MEMORANDUM

DATE: April 26, 2021

RE: **Response to Comments – BSC Group**
Proposed 40B Residential Development
91 Beatrice Circle – Belmont, MA

Exhibit 1
Stopping Sight Distance Evaluation
Site Driveway to Near Lane

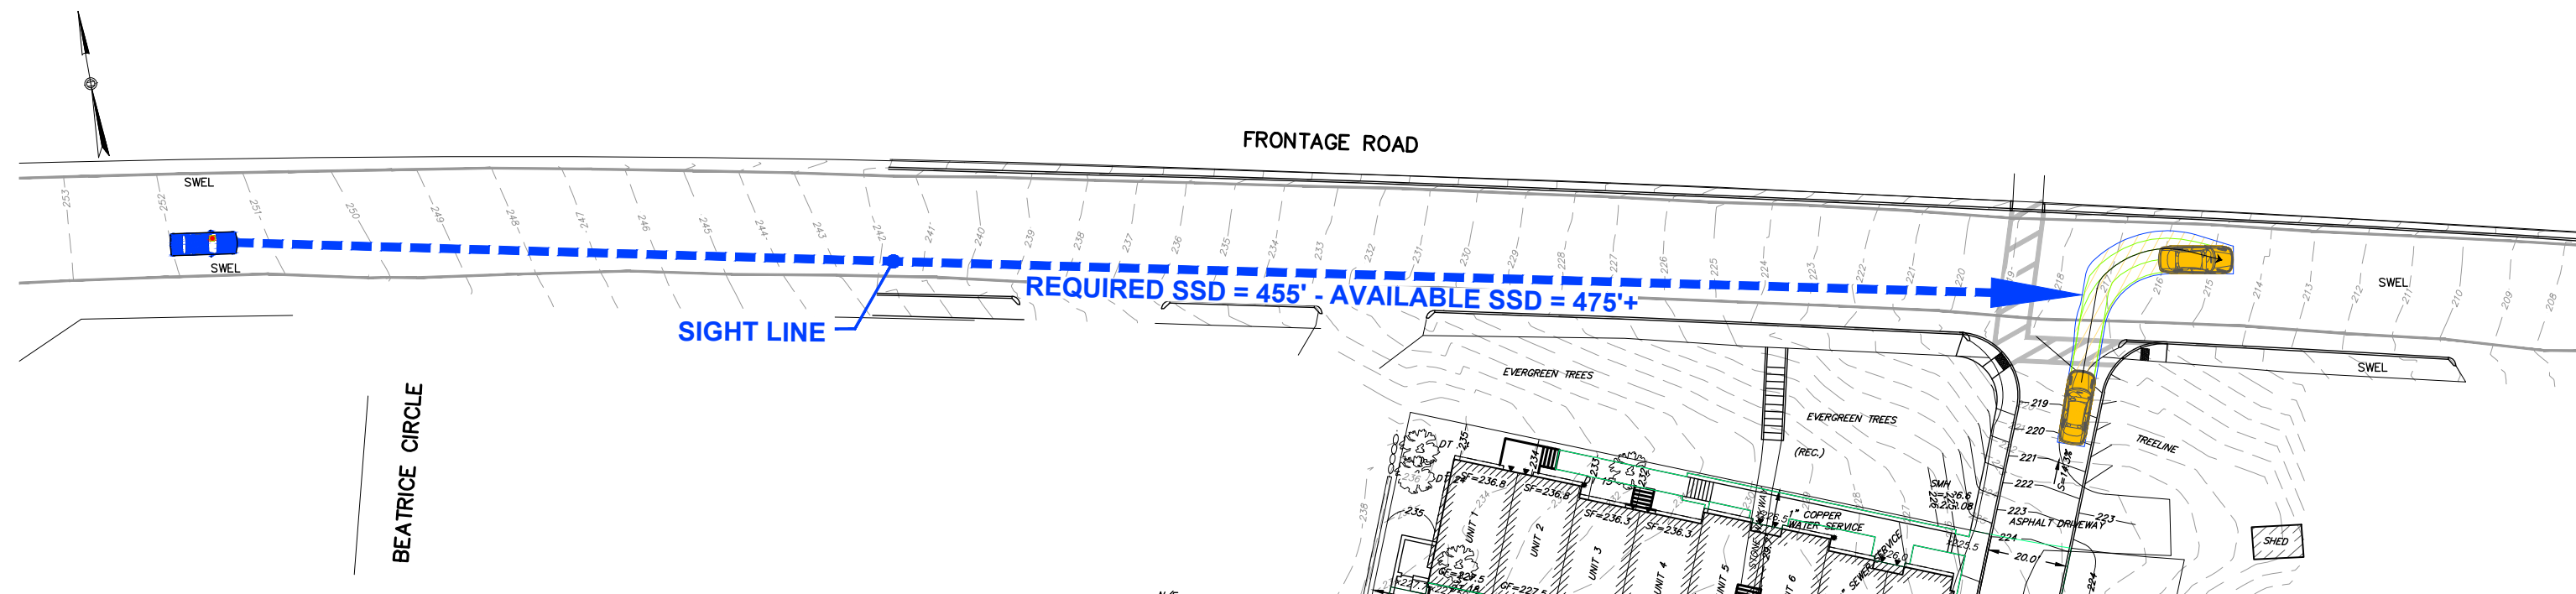
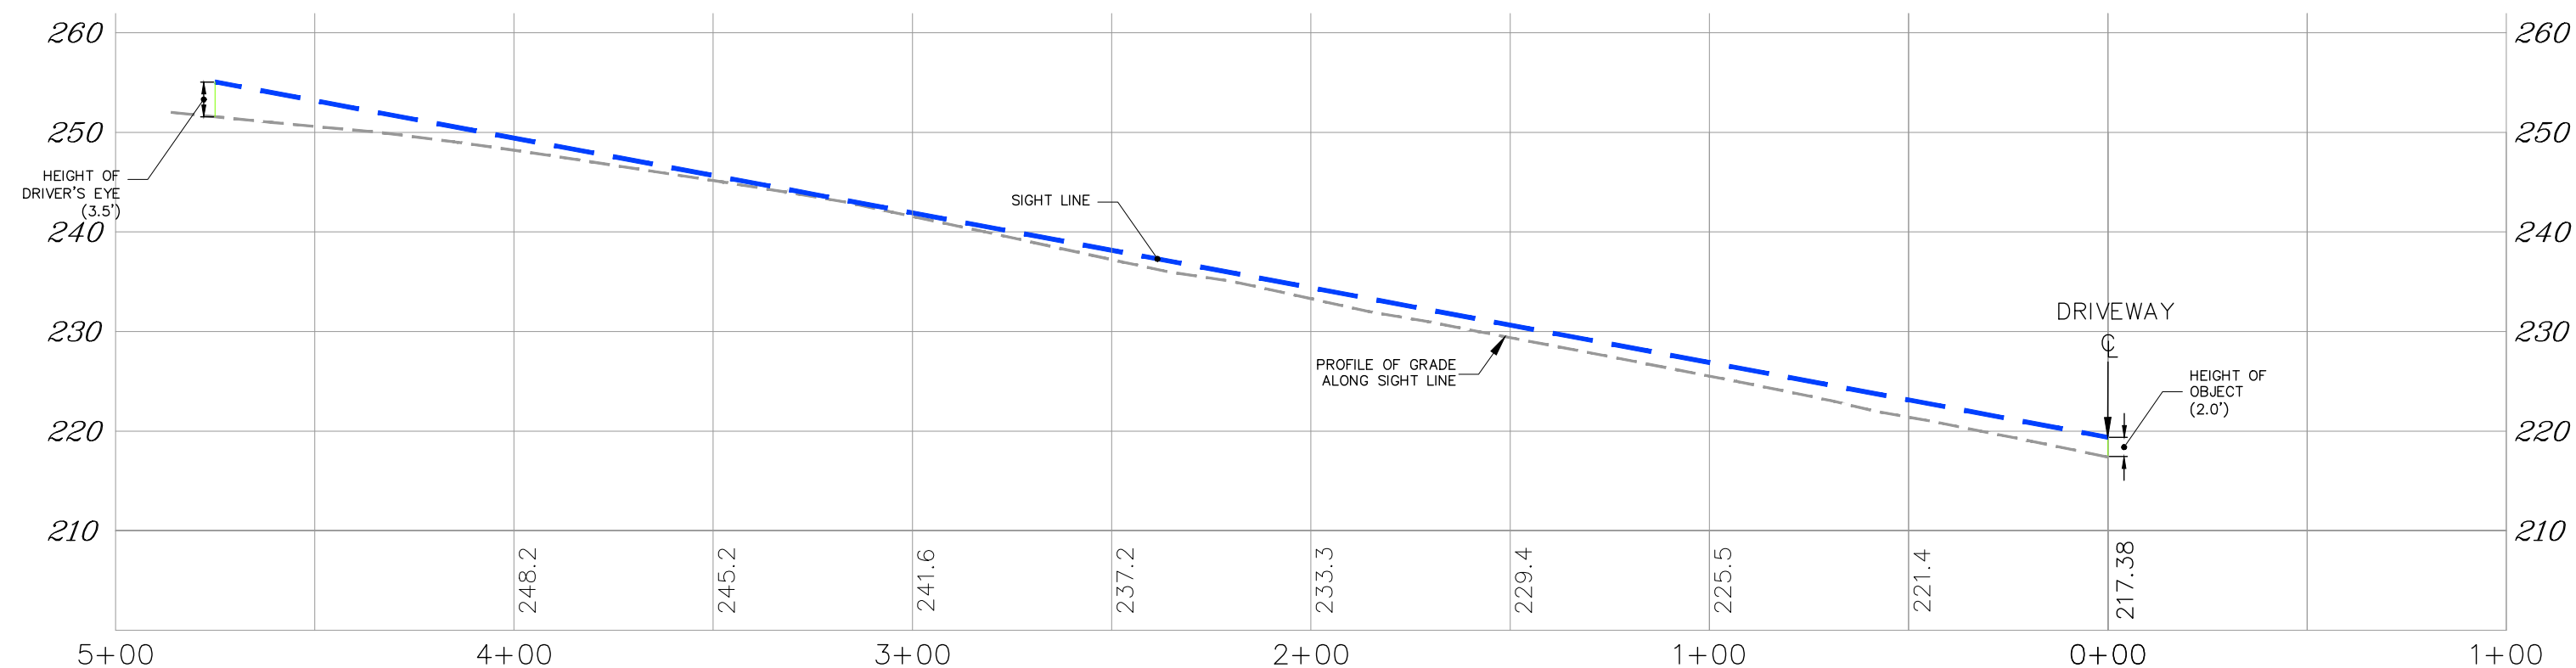
Comment 5: "BSC conducted a visit to the Project site to verify sight distances and to observe travel speeds along Frontage Road. Our site visit indicates that available sight distance is approximately 435 feet. BSC also observed vehicles to travel at or above 40 mph. We request that the Applicant determine the required SSD and recommended ISD for speeds of 45 mph."

MDM has prepared plan and profile exhibits for the site plan based on supplemental ground survey along the Frontage Road and the proposed driveway grading. Calculated sight line requirements are based on the supplemental speed data collected under the direction of BSC that include a 48 mph 85th percentile travel speed. Following AASHTO methodology the calculated minimum required stopping sight distance (SSD) for the eastbound vehicle approach is 455 feet based on an 85th percentile speed of 48 mph and an average approach downgrade grade of 7.2 percent as measured along an available sight line distance of 475 feet from the proposed driveway. Available Intersection sight distance (ISD) of 475 feet is also confirmed from ground survey, exceeding the minimum ISD requirement of 455 feet as well as corresponding “ideal” ISD for the eastbound Frontage Road approach.

Exhibit 1 and **Exhibit 2** indicate that the stopping sight distances (SSD) are exceeded for both travel lanes for the observed 85th percentile travel speeds along the Frontage Road. Likewise, **Exhibit 3** and **Exhibit 4** present the intersection sight lines (ISD) for the proposed site driveway indicating that criteria for ideal ISD are also met or exceeded for the observed 85th percentile travel speeds along the Frontage Road.
